**SECTION 00 9111
ADDENDUM NUMBER 1**

1.01 DATE: APRIL 20, 2026

1.02 PROJECT: TRUMANN MIDDLE SCHOOL - SYSTEMS REPLACEMENT

1.03 PROJECT NUMBER: 2402

Sheet Name: KITCHEN HOOD SYSTEM - HVAC
 Project No: 1631 Date: 3/20/26
 Sheet No: M504

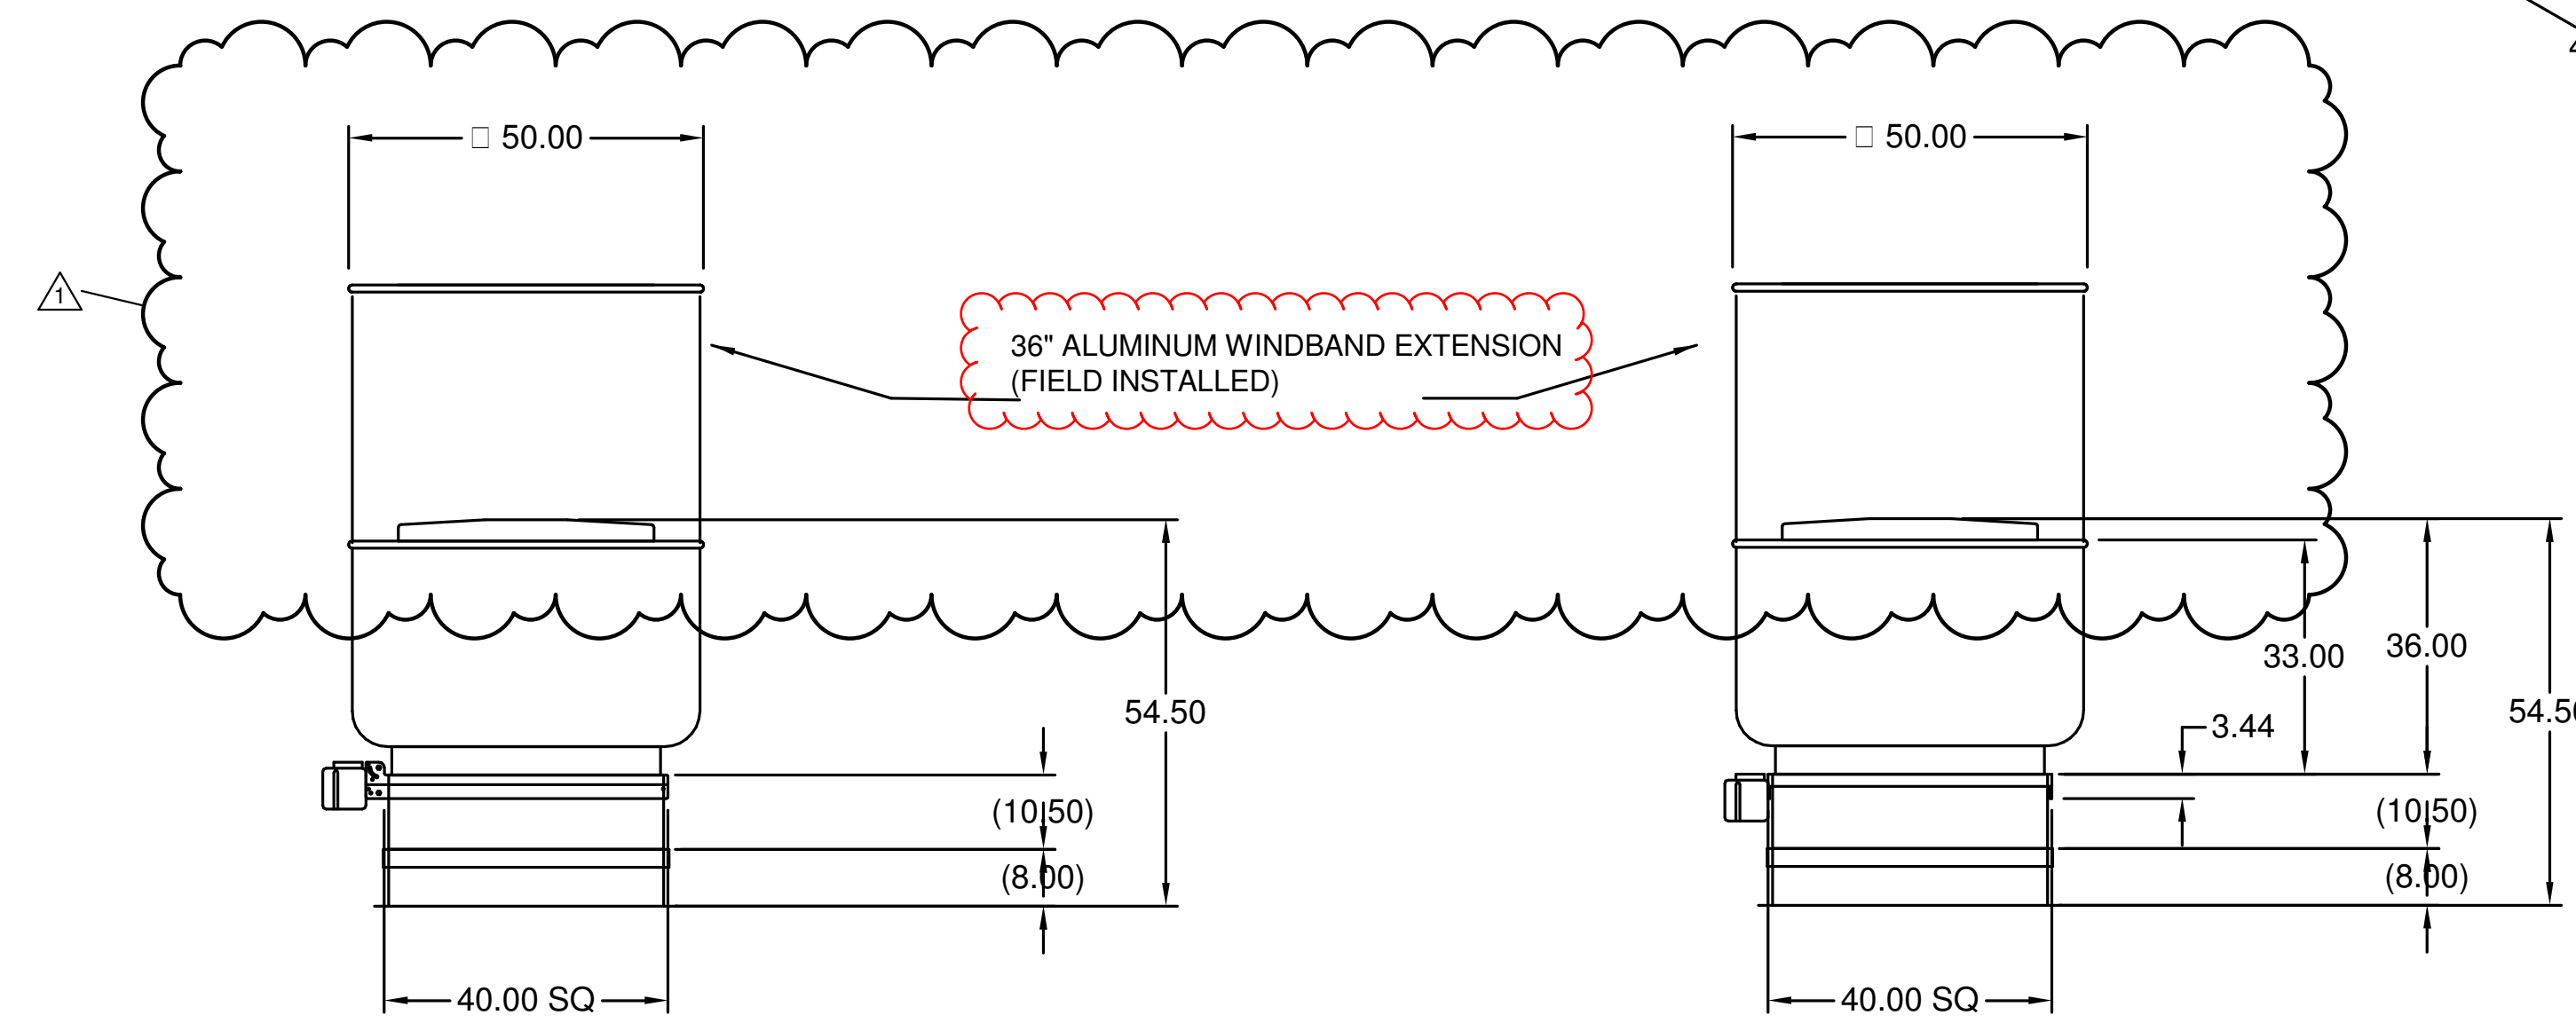
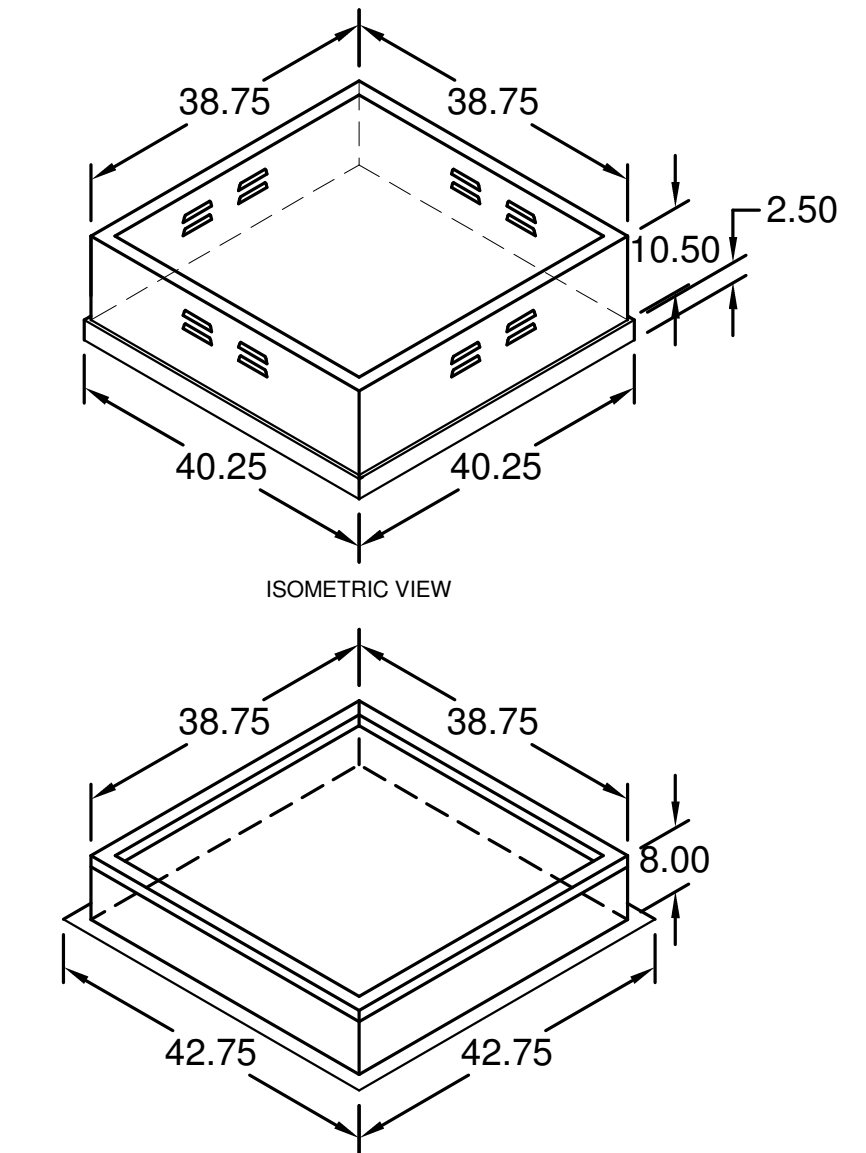
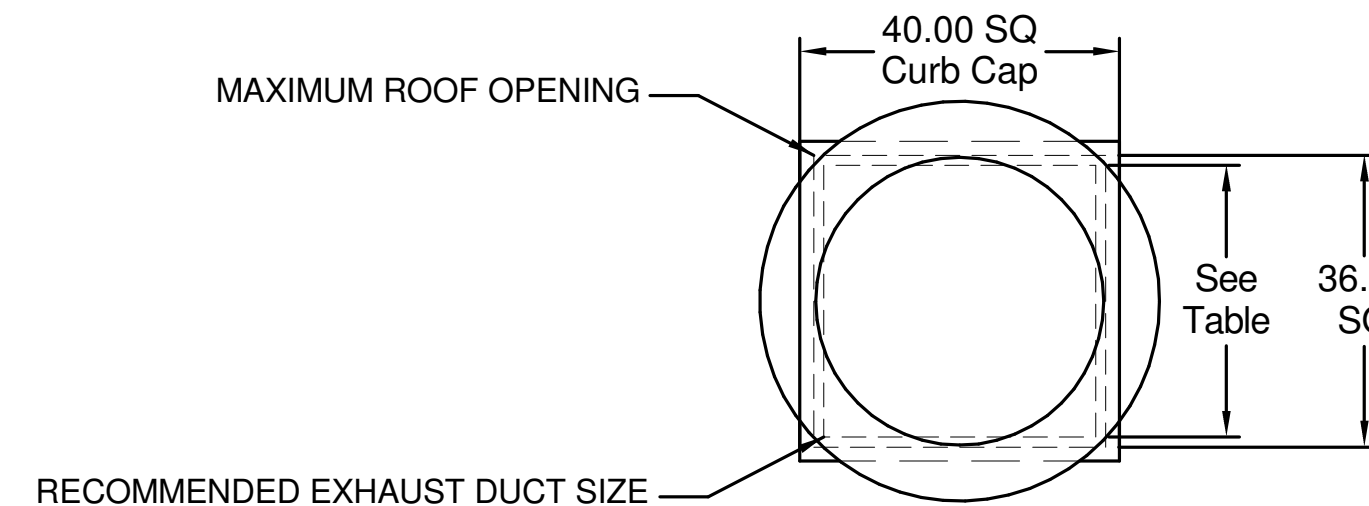
4.09 DRAWING SHEET M504:

- A. Revise motor data in exhaust fan schedule for KEF-1. Revise voltage to 208/3 phase. Revise FLA to 10.6.

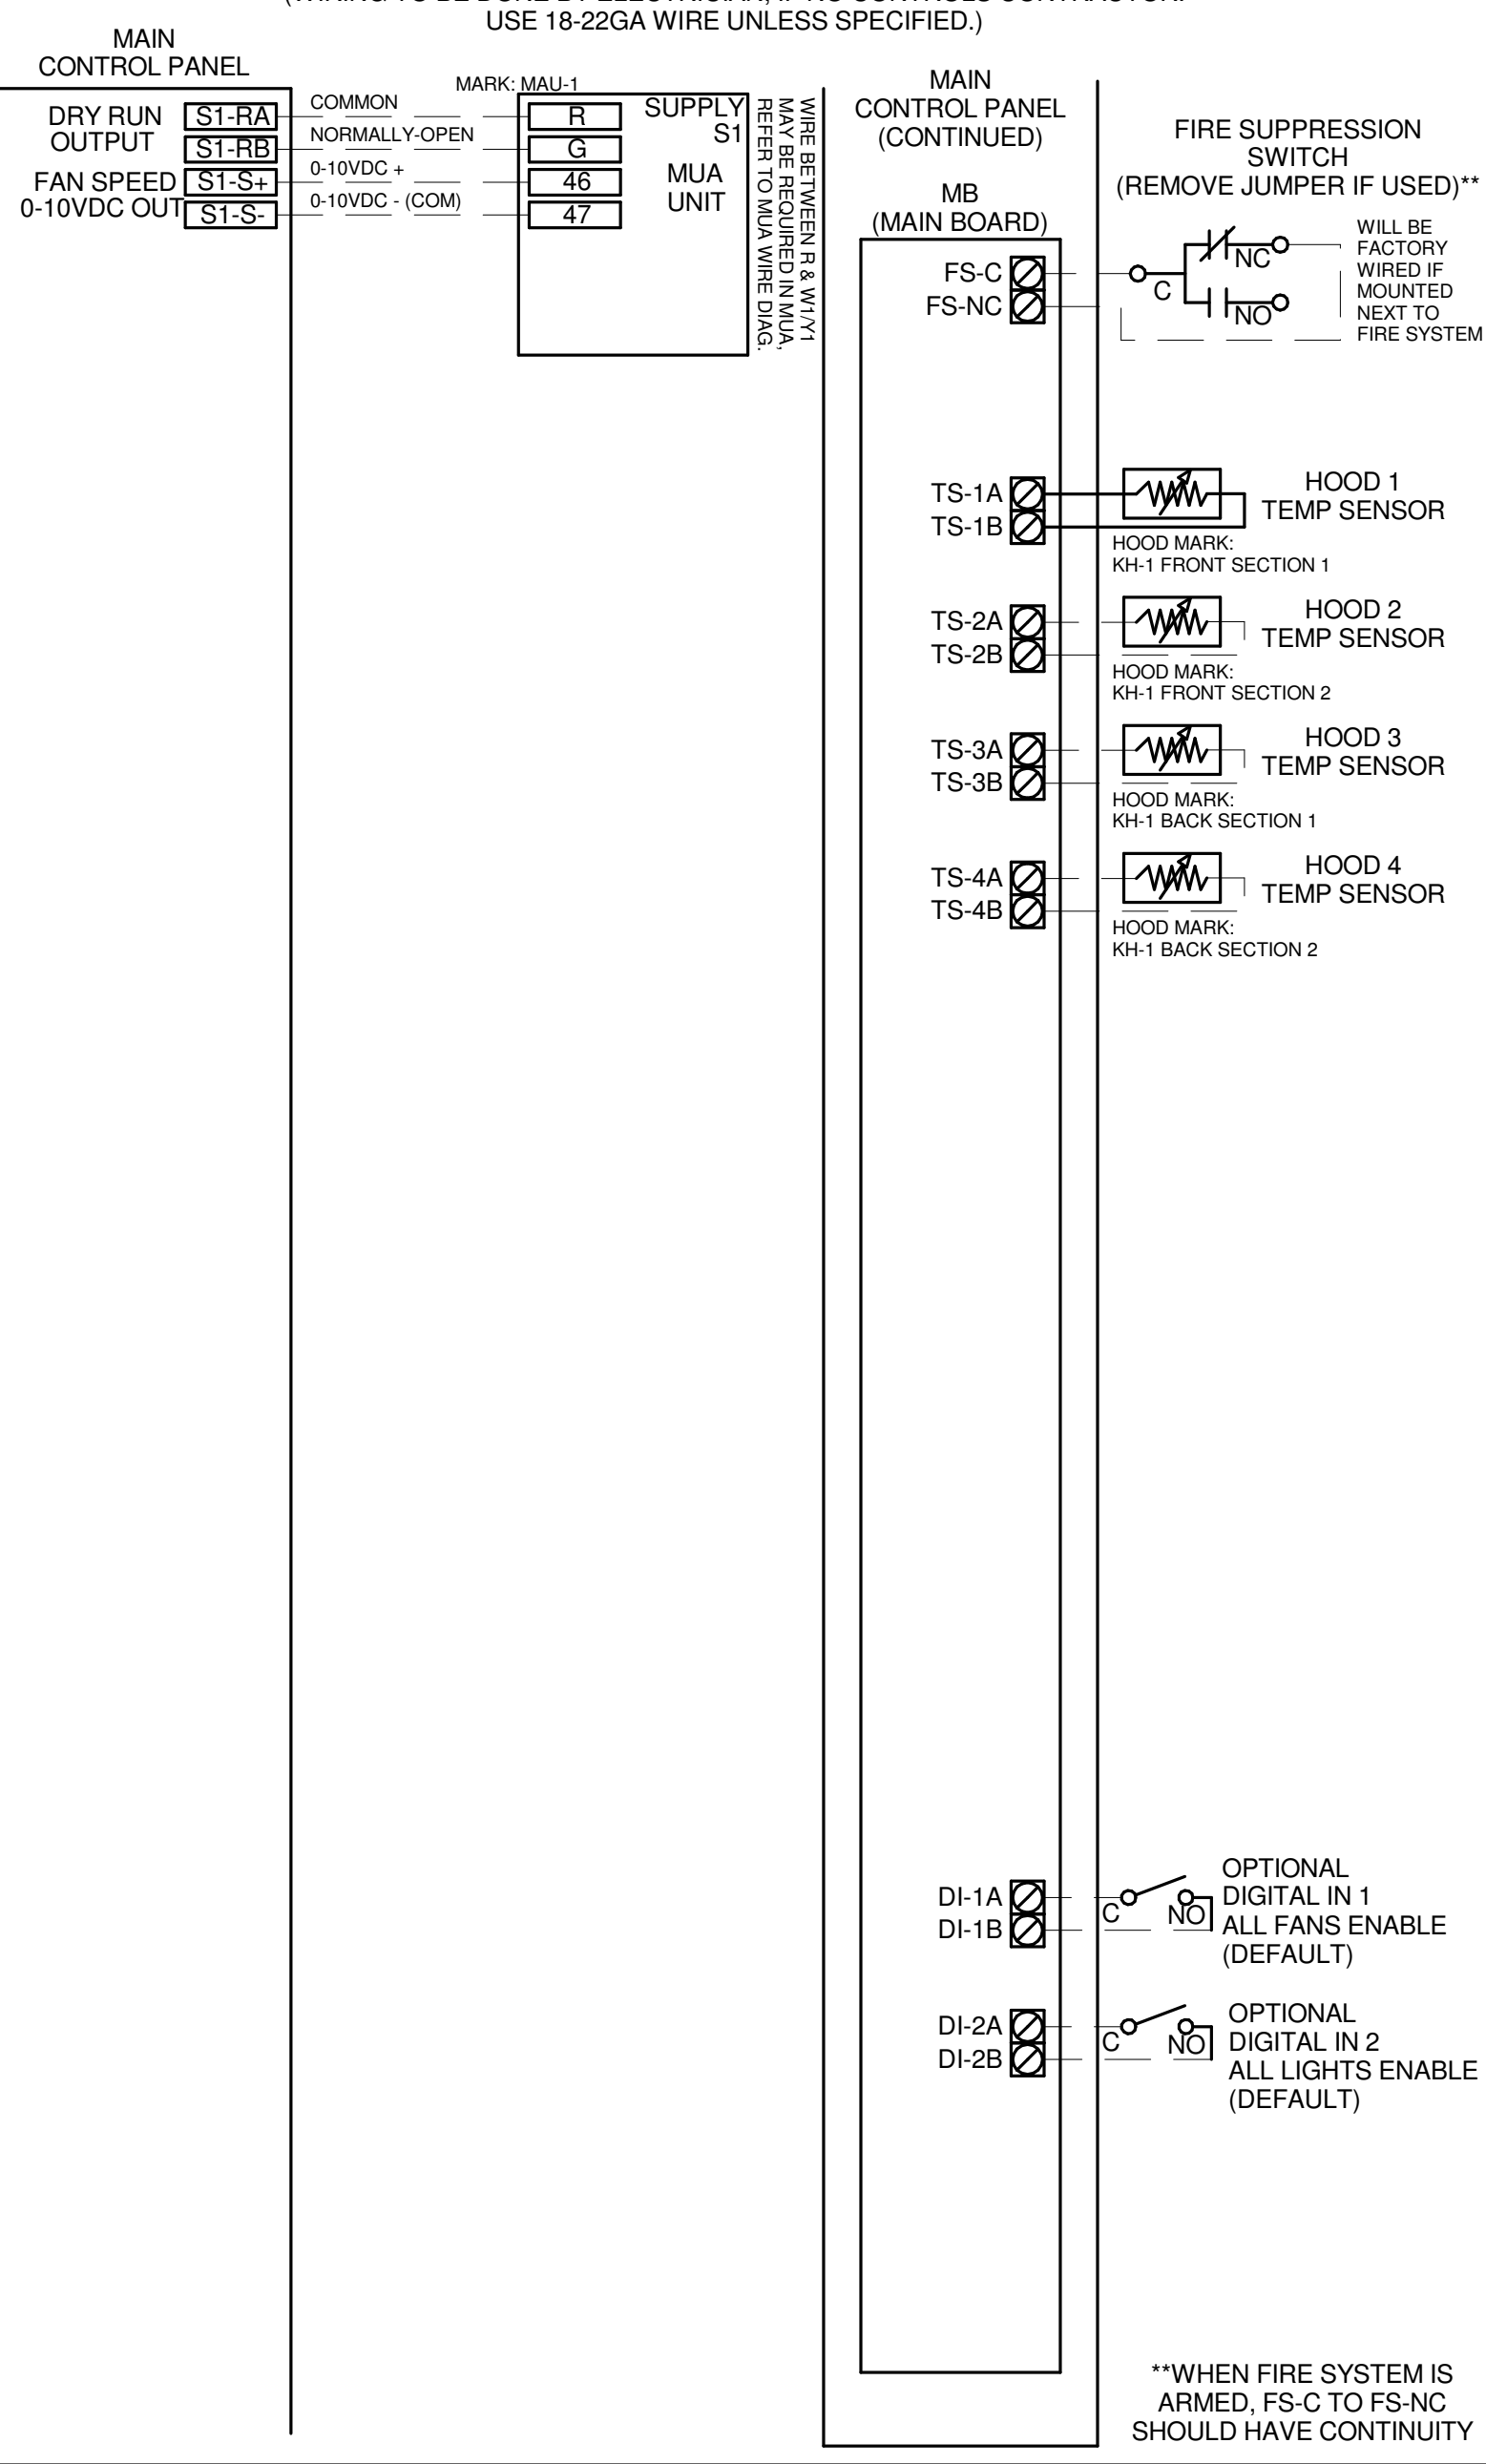
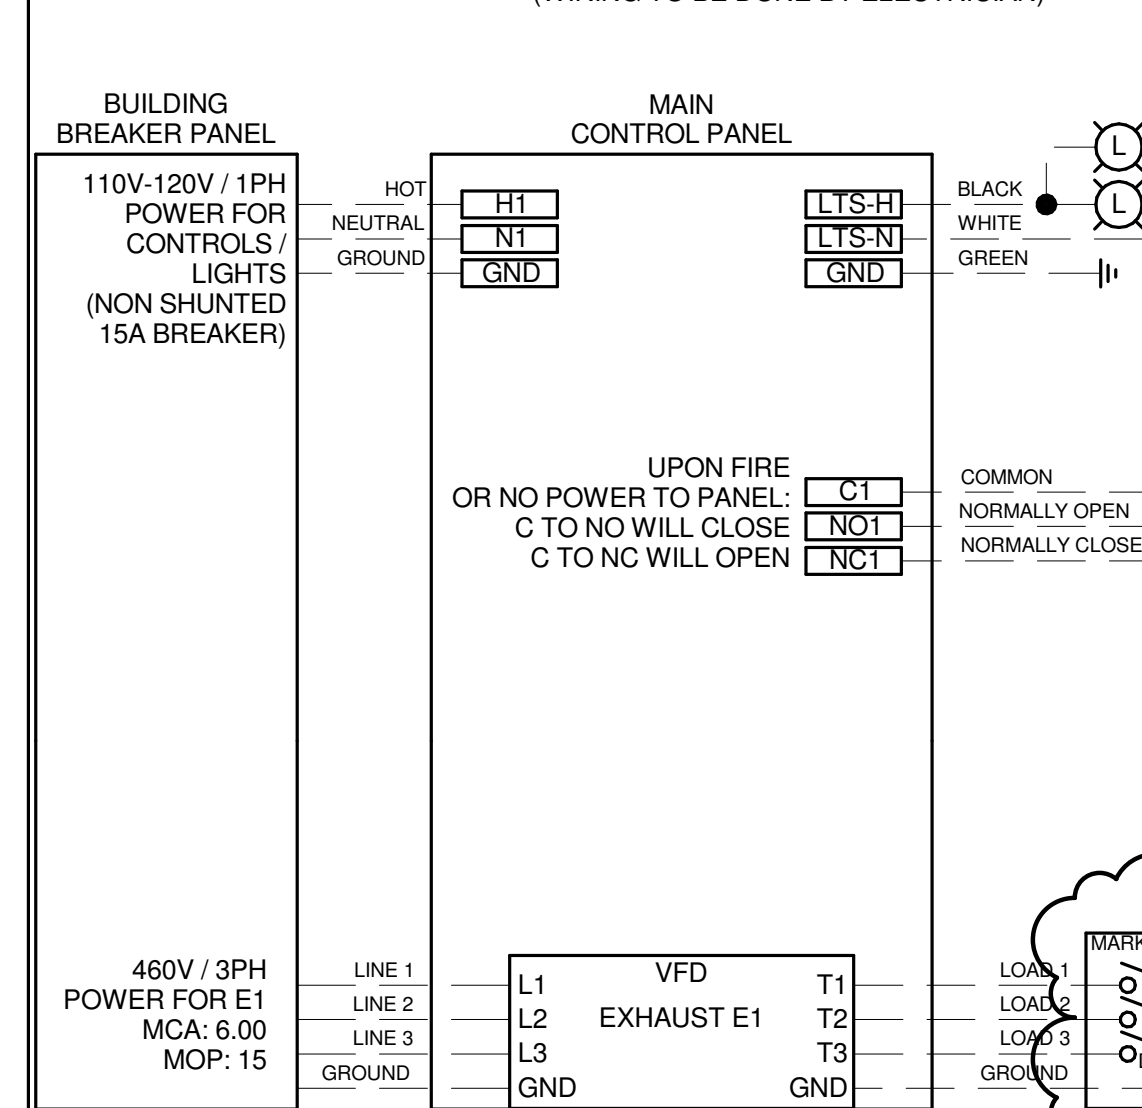
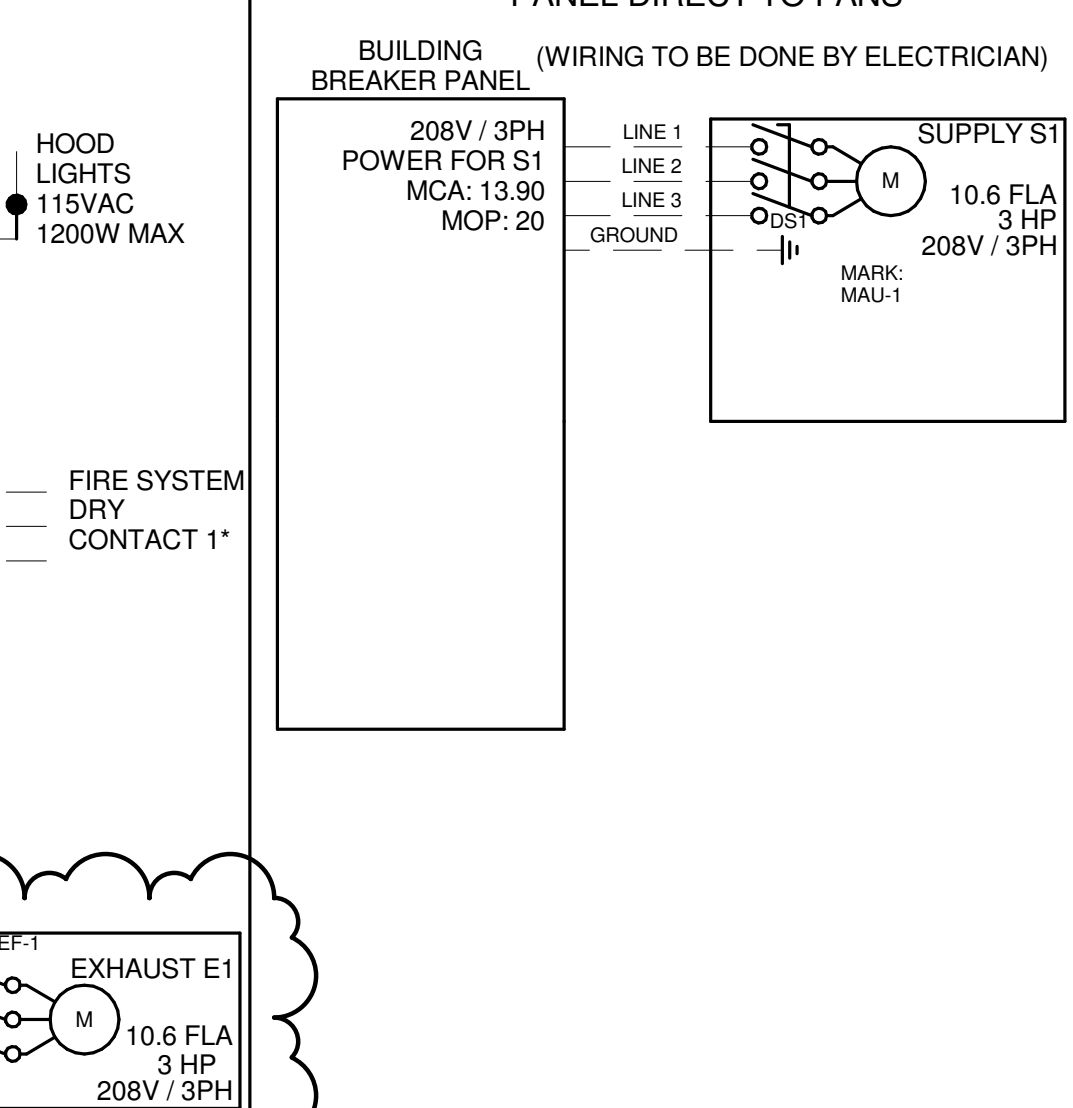
4.10 DRAWING SHEET M505:

- A. Revise motor data in main control panel wiring diagram for KEF-1. Revise voltage to 208/3 phase. Revise FLA to 10.6.
